CITY OF PORTLAND, MAINE

HISTORIC PRESERVATION BOARD

HISTORIC PRESERVATION BOARD MEETING

**WORKSHOP
21 ORCHARD STREET**

3D VIEW OF SUNPORCH ADDITION FROM GARAGE ROOF

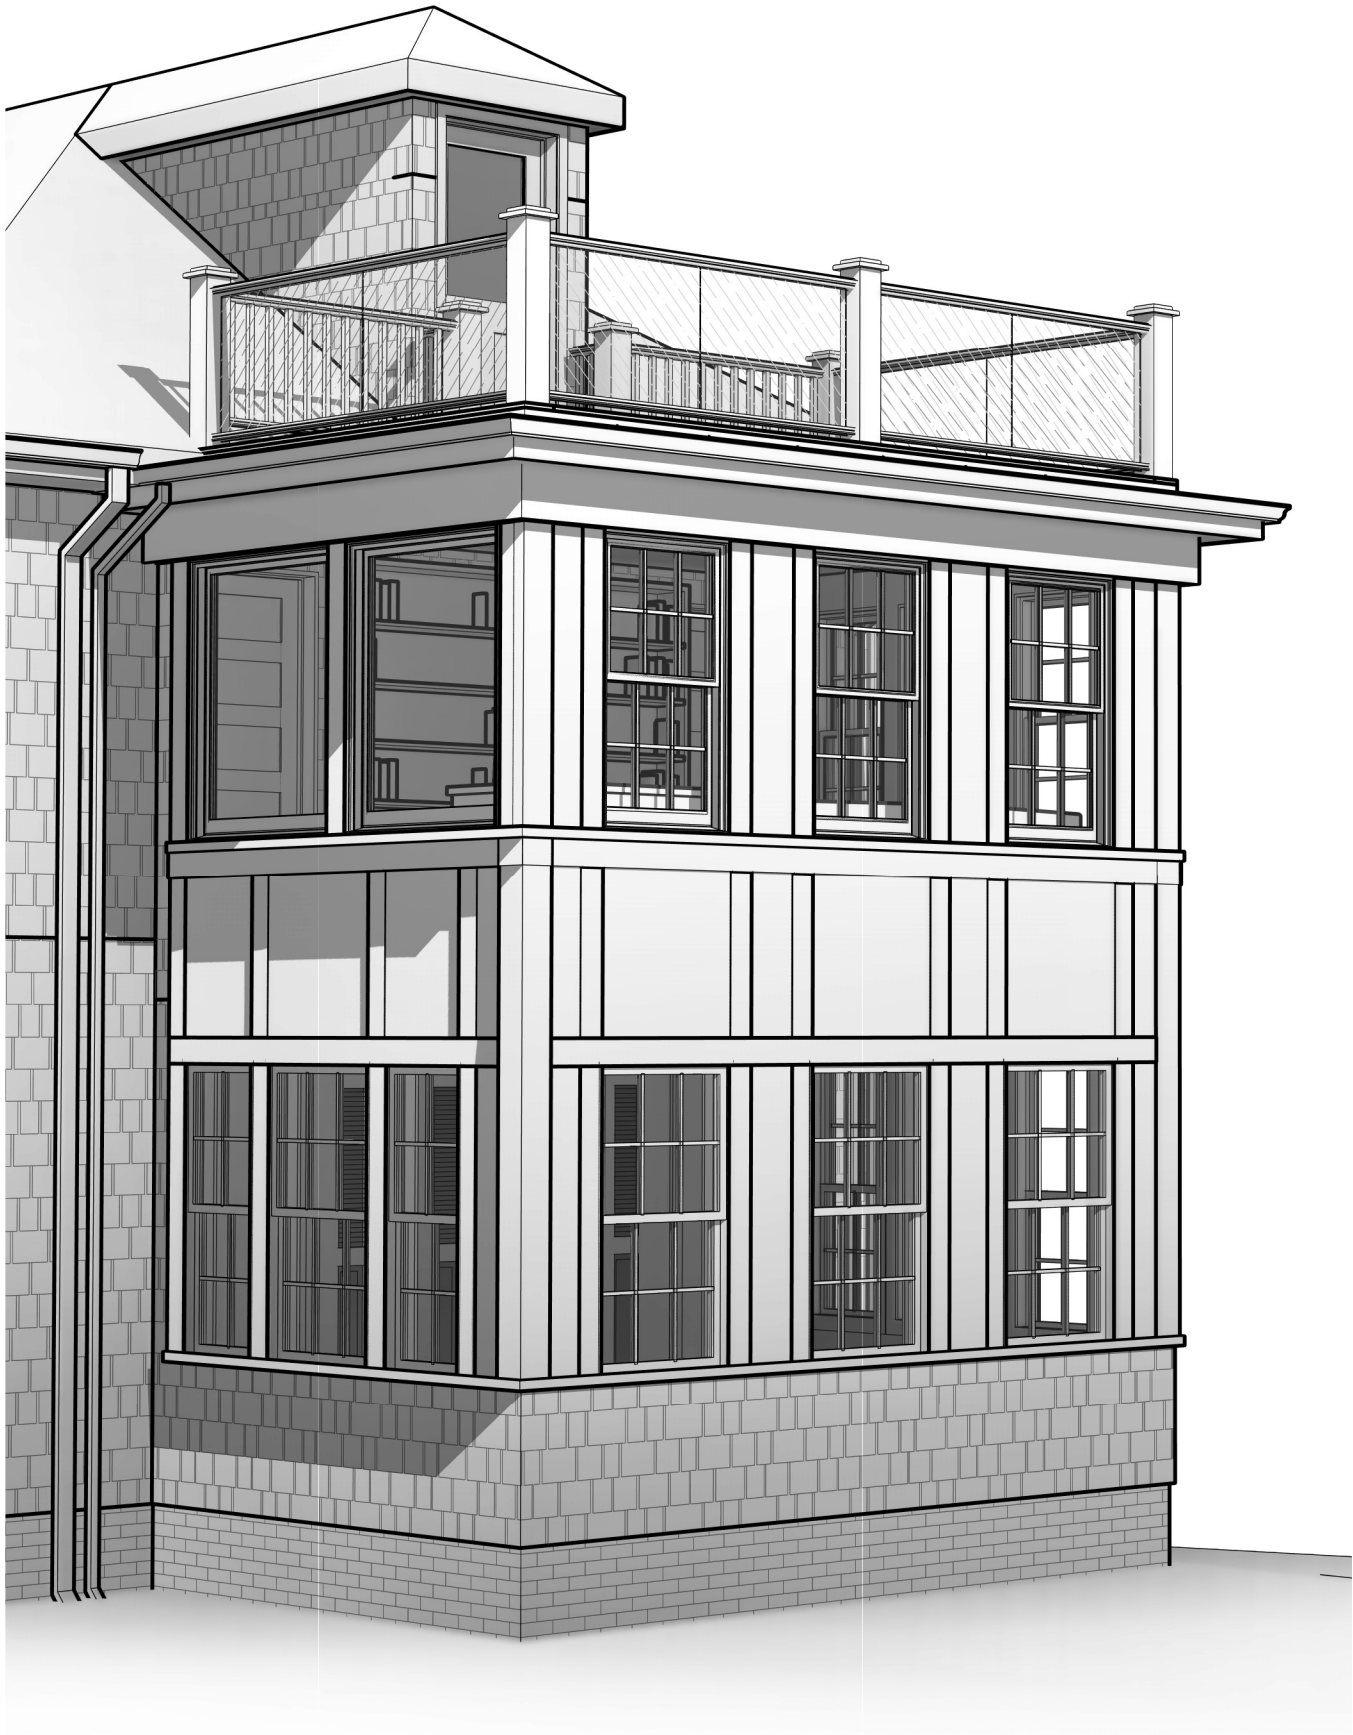
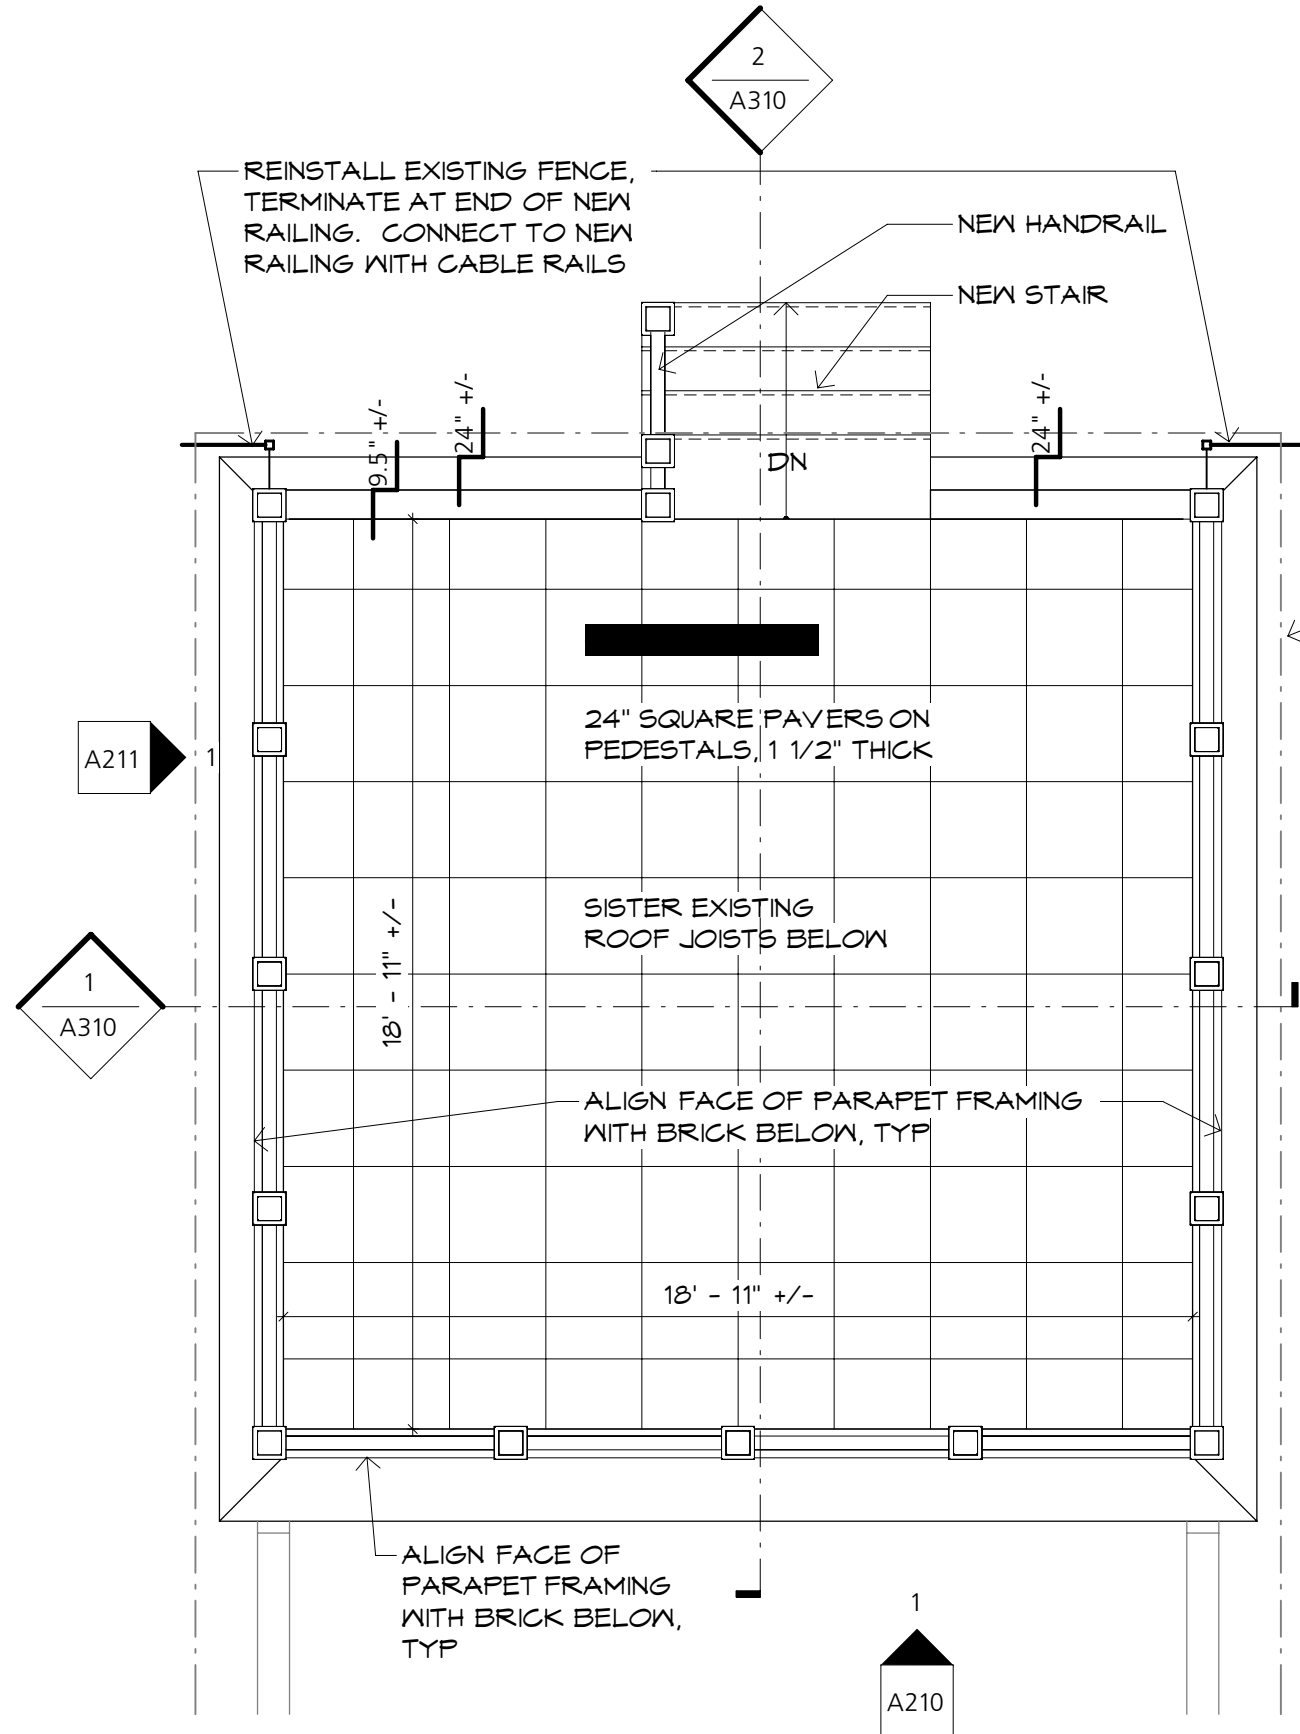
The proposed deck and railing system above the second floor is set back from the edge of the roof such that the posts align with the cornerboards of the sunporch structure. The proposed railing system consists of square posts with simple caps and non-reflective glass panels between posts. The glass panels will be set within a top and bottom rail. A natural finish mahogany top rail is proposed. The elevations show a standard balustered railing adjacent to the roof. Board members should confirm whether this change is intentional or a drafting error.

In this instance, staff is not of the opinion that a clear distinction needs to be made between the architectural treatment of the original sunroom and that of the proposed second-story addition. Here, the decision to provide a consistent architectural treatment throughout appears appropriate. The proposed addition to the sunroom, including the roof deck, and the modifications to the western roof dormer appear compatible with the existing structure and the detailing has been carefully considered throughout. Note, for example, that the deck has been set back from the roof edge in such a way that the corner posts of the railing extend directly above the corner trim boards of the addition.

The use of glass in lieu of a more traditional railing system around the roof deck is the one aspect of the proposed addition that, in staff's view, might warrant further discussion. Nontraditional railing systems have been approved for a number of projects, but typically in secondary, less visible locations. That is not the case here. That said, the glass panels are set between traditional wood posts and wood top and bottom rails, which do help integrate the proposed treatment with the overall vocabulary of the building.

View 2

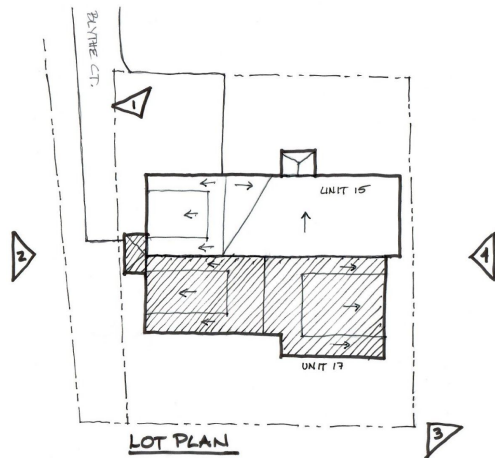
- The proposed shed dormers are larger than the existing dormer on the southwest roof of 15 Blyth. (See View #2, p. 8 of slide show.) Could the new dormers be lowered to match the existing dormer and be less prominent?
- The square block of 17 Blyth already dominates to some degree the sloping roof and dormer of 15 Blyth, but it is not significantly taller. With a third floor, even with a sloping roof 17 Blyth would be the predominant section of the overall form in part because of the large shed dormers.
- Staff considers the immediate context of the subject property to be the cul-de-sacs now known as Blyth Court and Houlton Street. While most of the nearby houses are 2-1/2 stories, the large gable proposed for the addition may make 17 Blyth feel larger than its neighbors. Whether it would be significant enough to make the relationship uncomfortable and incompatible is hard to know.

Site Plan
Scale: 1" = 10'
Proposed

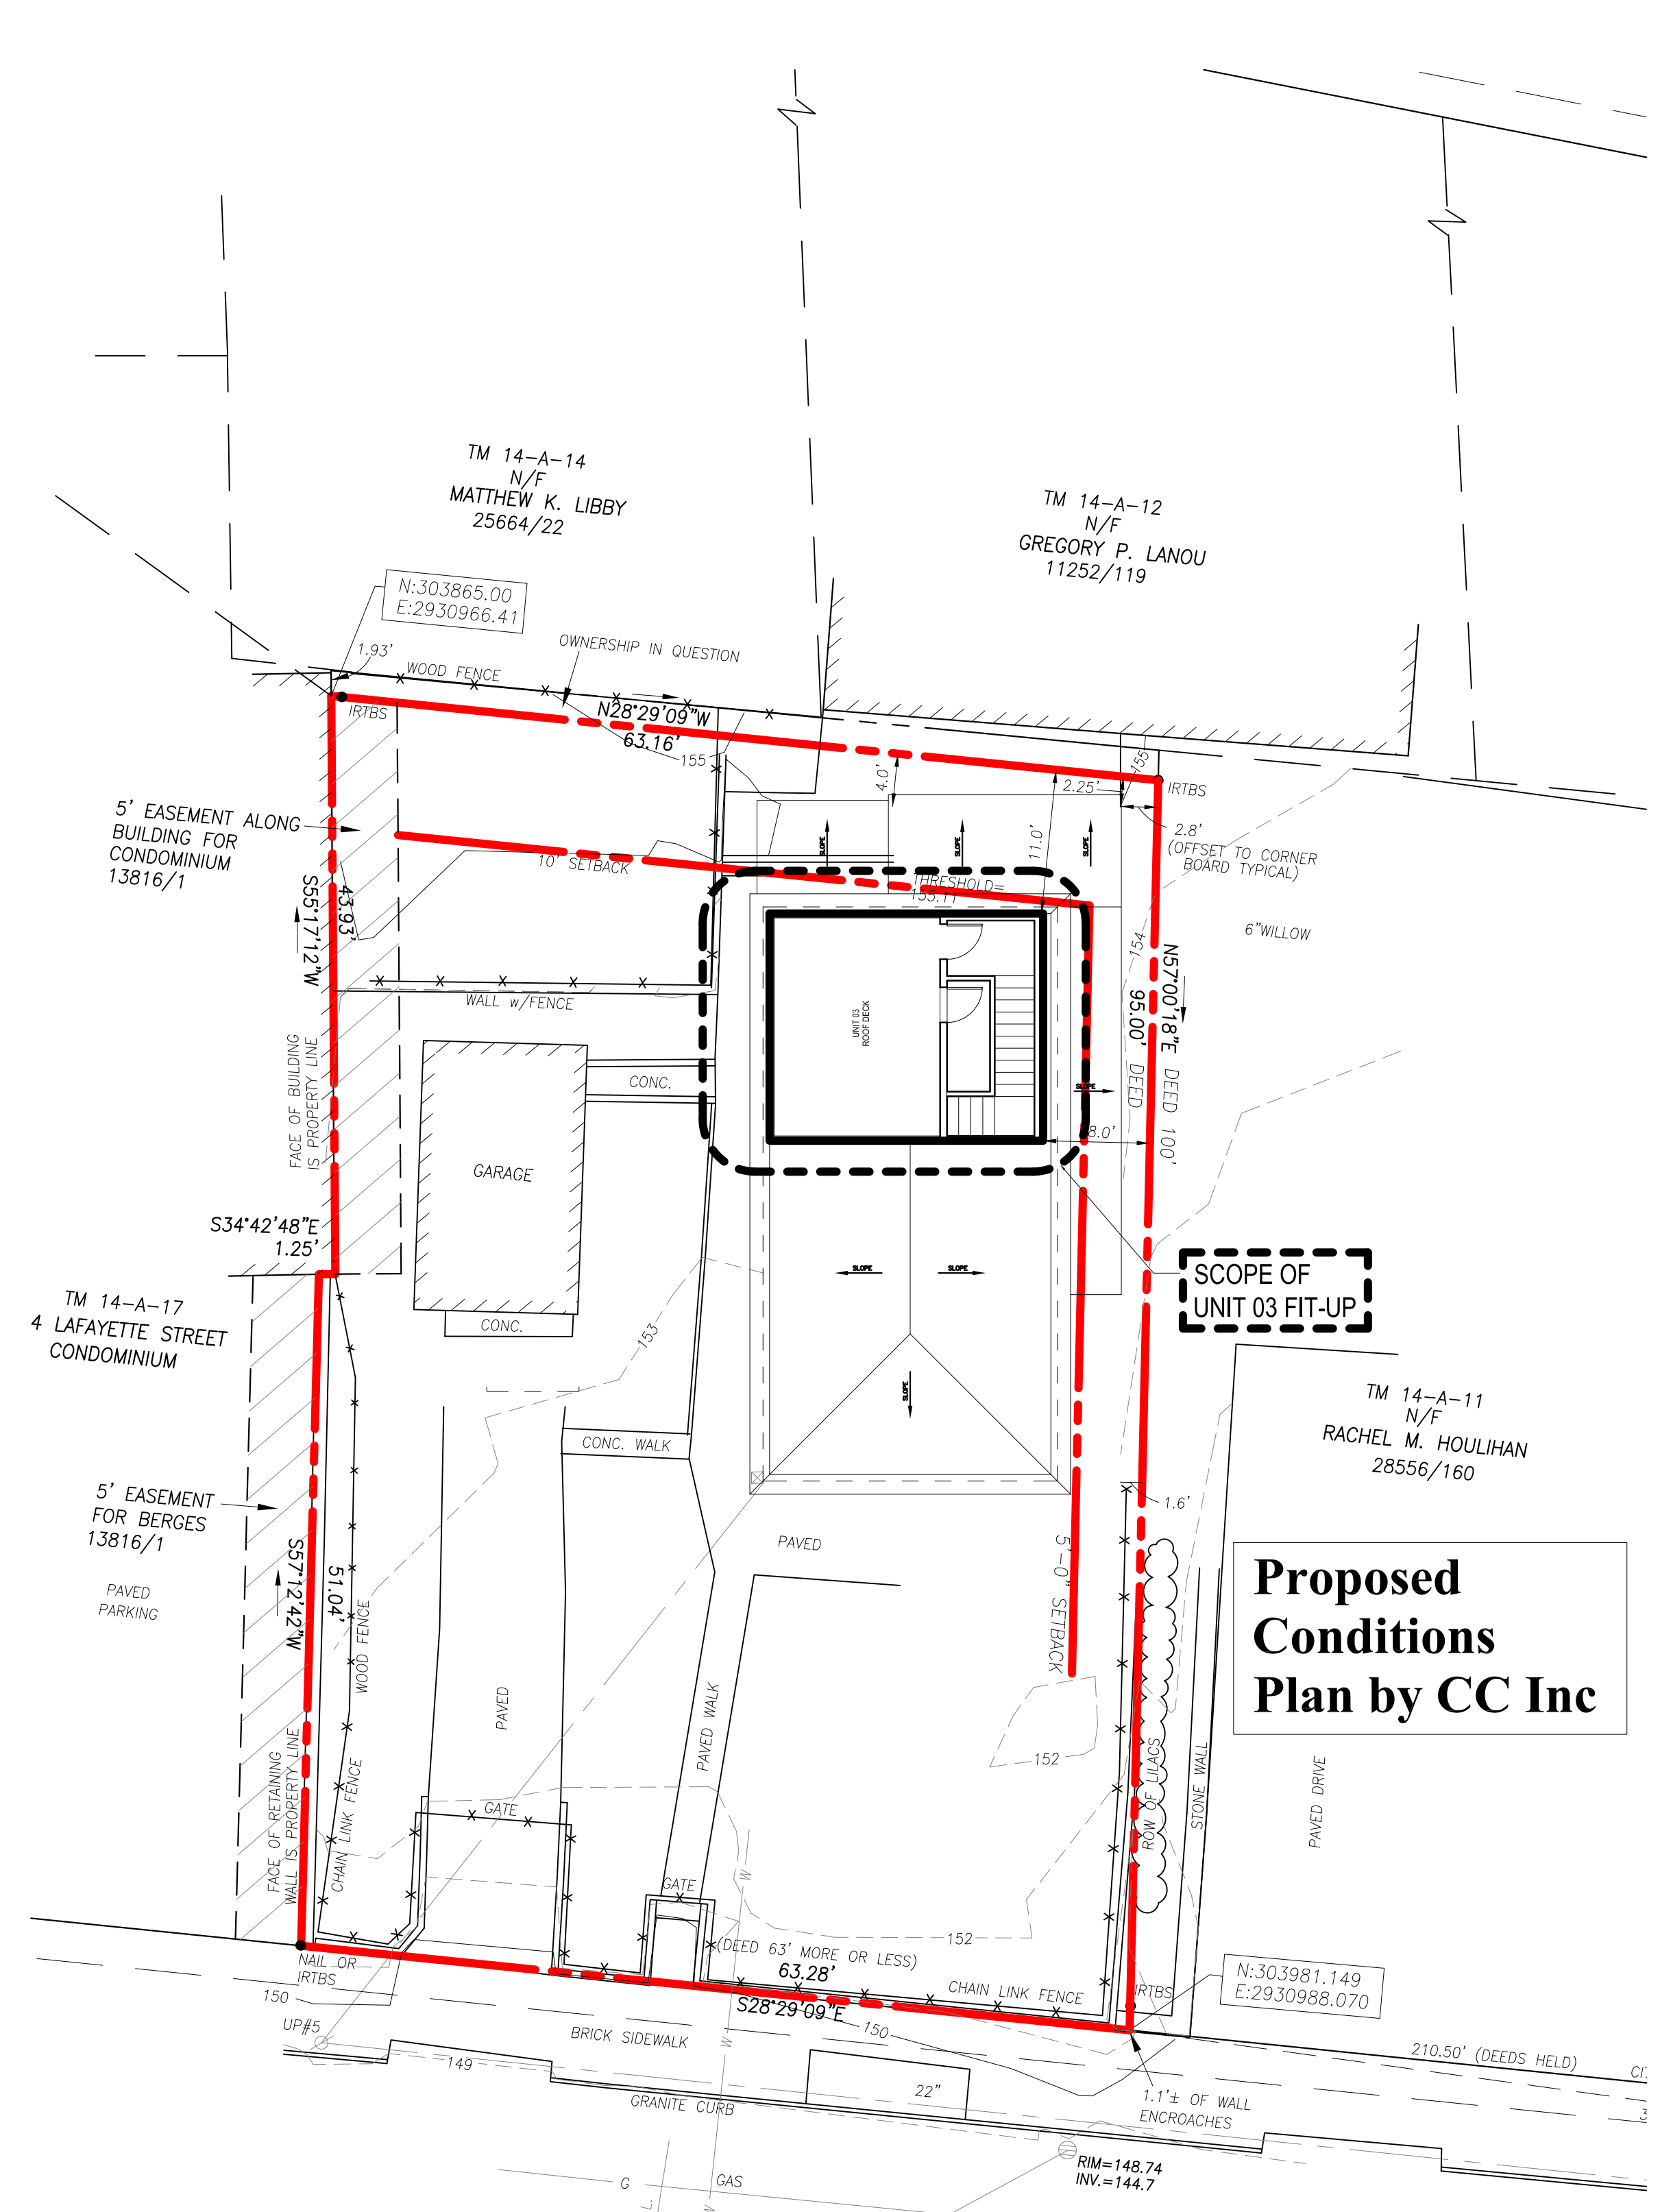
As part of a larger scope of landscape improvements, the applicant is also proposing to replace the existing chain link fence on the property with a decorative aluminum fence. See enclosed site plan and catalogue cut—ATTACHMENTS 6 and 7. The height of the fence is not indicated on the plan, but the applicant has indicated it will be a 4' fence.

The proposal to replace the chain link fence with an ornamental metal fence is welcome. The applicant had also explored replacing the deteriorated concrete retaining wall at the sidewalk edge, but is not pursuing that improvement at this time. Spreading vegetation is proposed to obscure the concrete.
